OOC Intermodal Area – Surface Transport Issues

17 October 2023

Old Oak Common Surface – High level concerns

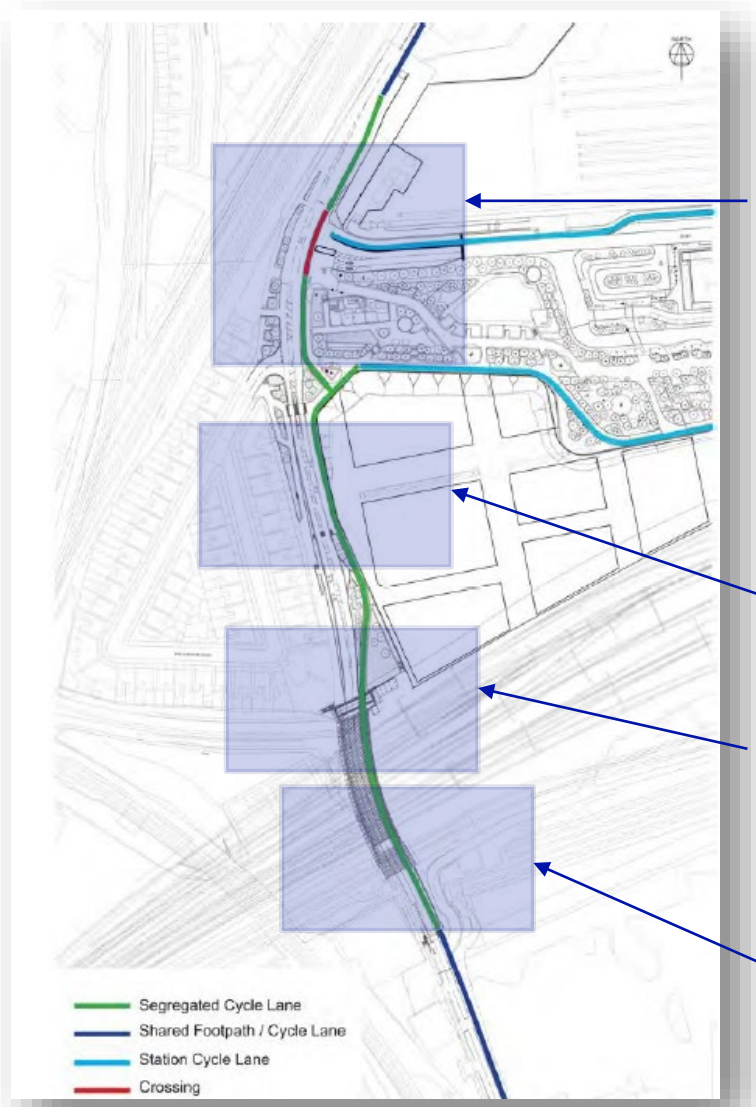
Disjointed assessment

- HS2 surface modelling does not account for OPDC growth or terminus operations. No assessment of on-site congestion. Very light touch approach for such a significant interface.
- HS2 design packages have split the site (access/intermodal/station) but they must work together and then liaise with OPDC plans for wider area.
- Current approach for understanding surface transport is unorthodox. For example;
 - Vehicle forecasts have unclear lineage to strategic models with departures agreed between HS2/BBVS. TfL have requested numerous times to see source data as numbers appear low.
 - Pedestrian forecasts do not include OPDC growth, ASD, and terminus operations. Design therefore does not account for all sources of people who might be attracted to OOC like visitors, staff, on site residents, etc.

Old Oak Common – Bus Concerns (WPI3)

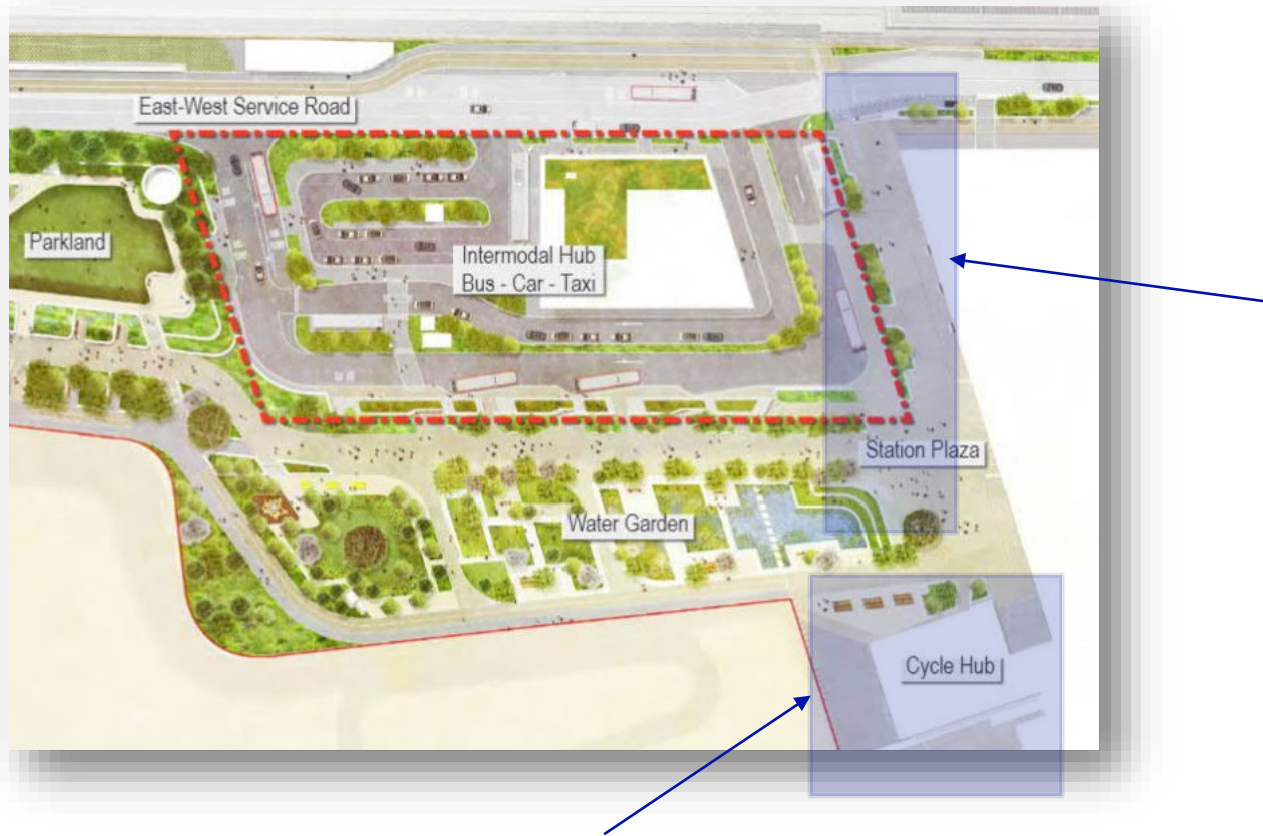
- Not enough stops and stand spaces to deliver OPDC future bus network.
- Passing tolerances between stationary and moving buses are extremely tight on bus loop. Increased risk of collision and closures.
- Blue badge parking means private vehicles will share bus loop. Mixing non-operational vehicles is high risk.
- Safety issues with unfamiliar sawtooth stop arrangement being used to save space.
- Bus recovery is not possible from the loop. Wrecker vehicles do not track.
- Driver welfare is too small. No natural light or ventilation. No fit out design provided.
- No operational TfL parking for incident response to manage signals or buses.
- Crowding has not been modelled outside station with no assessment of perturbations.
